UNITED STATES PATENT AND TRADEMARK OFFICE

APPLICATION NO.	FILING DATE	FIRST NAMED INVENTOR	ATTORNEY DOCKET NO.	CONFIRMATION NO.
10/619,017	07/14/2003	Stephen C. Thatcher	10,220	8801

Office Action Summary

DETAILED ACTION

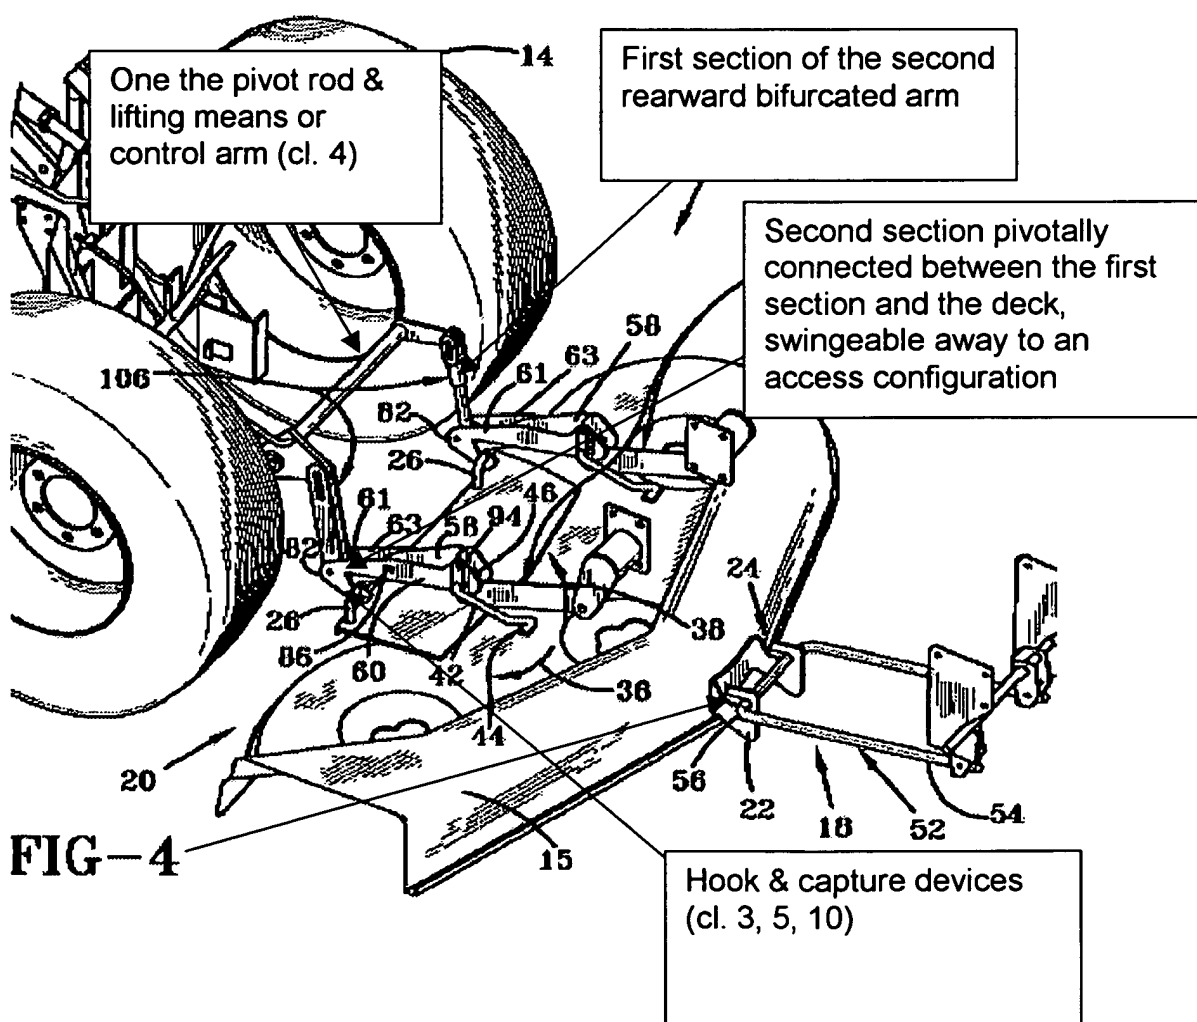
2. Claims 1-16, 20-27 are rejected under 35 U.S.C. 102(b) as being anticipated by Plas et al (6293077).

in re claims 6, 10, 12:

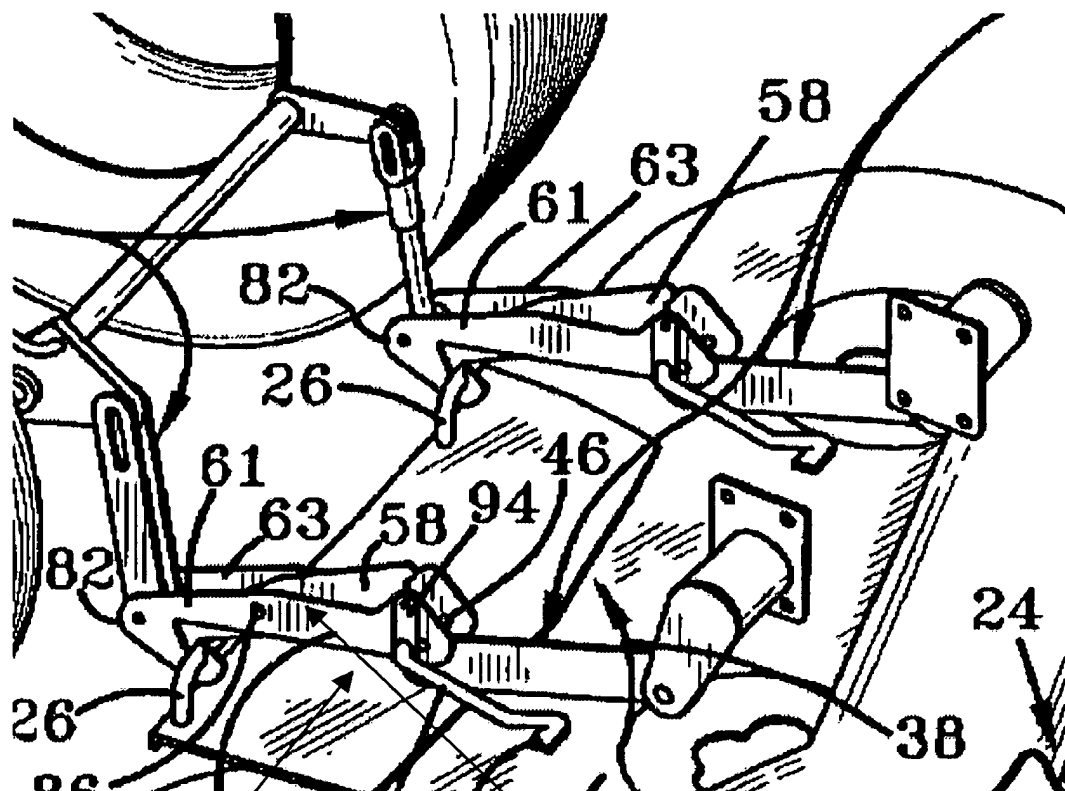
Stop includes a pin

Stop arm

Applicant appears to argue that claims 10-16 include a structure not shown by Plas, namely a stop pin, however only claim 12 recites: "stop arm ... position stop includes a pin" which is met by Plas as further detailed above.

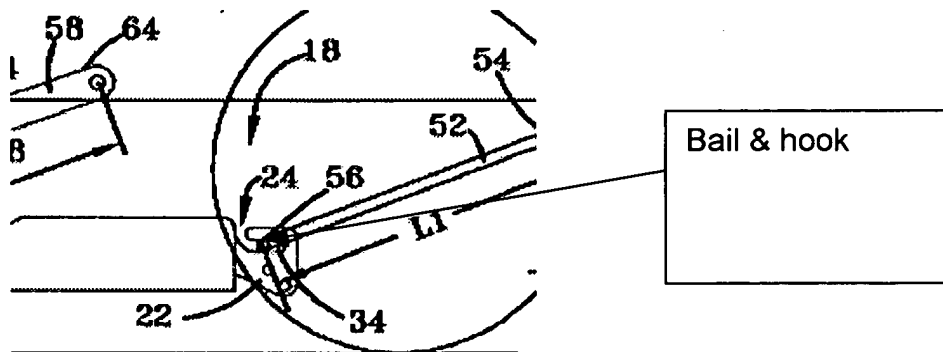
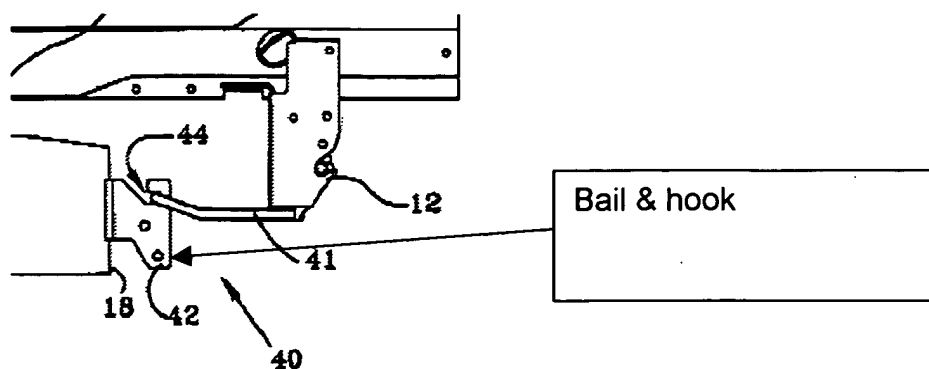
4. Claim 28 is rejected under 35 U.S.C. 103(a) as being unpatentable over Plas et al (6293077) or Schmidt (5956932).

Plas or Schmidt prior art discloses the claimed invention except for arranging the hook & bail in reverse order (cl. 28).

Plas shows the bail/hook arrangement:

Schmidt shows the bail/hook arrangement:

It would have been obvious to one having ordinary skill in the art at the time the invention was made to arrange the hook & bail reversely as claimed, since it has been held that a mere reversal of the essential working parts of a device involves only routine skill in the art. *In re Einstein*, 8 USPQ 167.
